PRODUCT CHANGE NOTICE

PCN26-041

ZN3PD-622W-S+

Change in typical performance. No Change in Specs

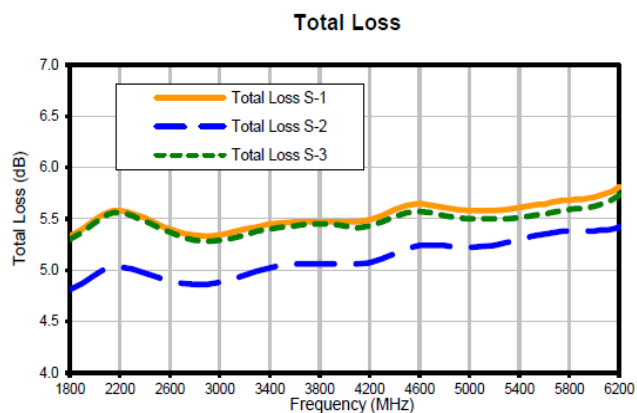
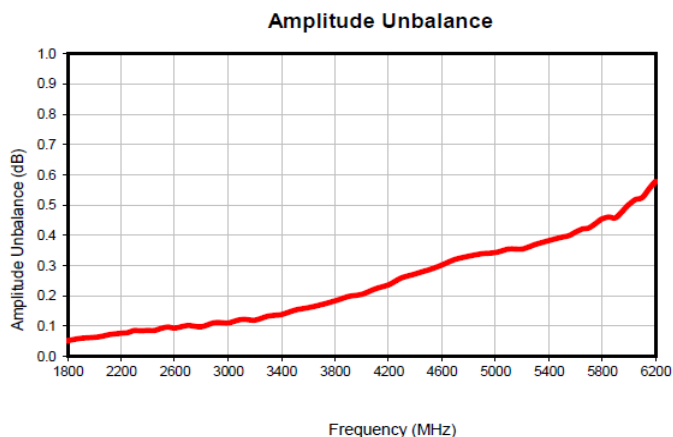
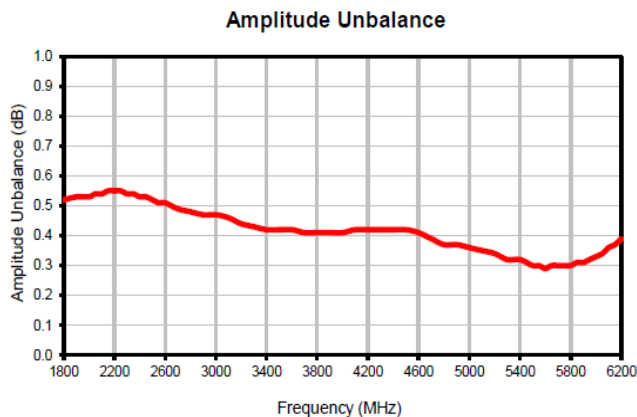
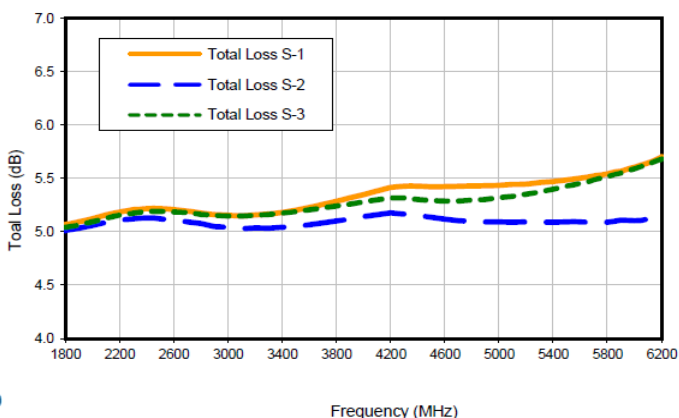
Change From:

Change To:
Total Loss

Isolation

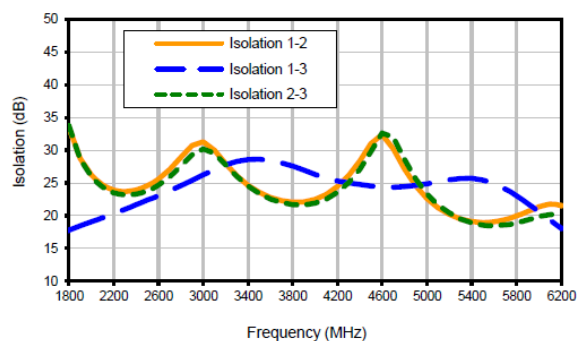
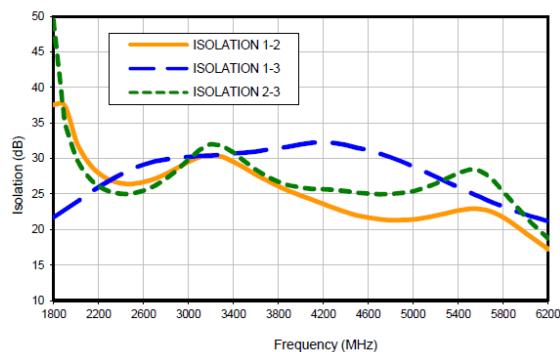
Change From:

Change To:
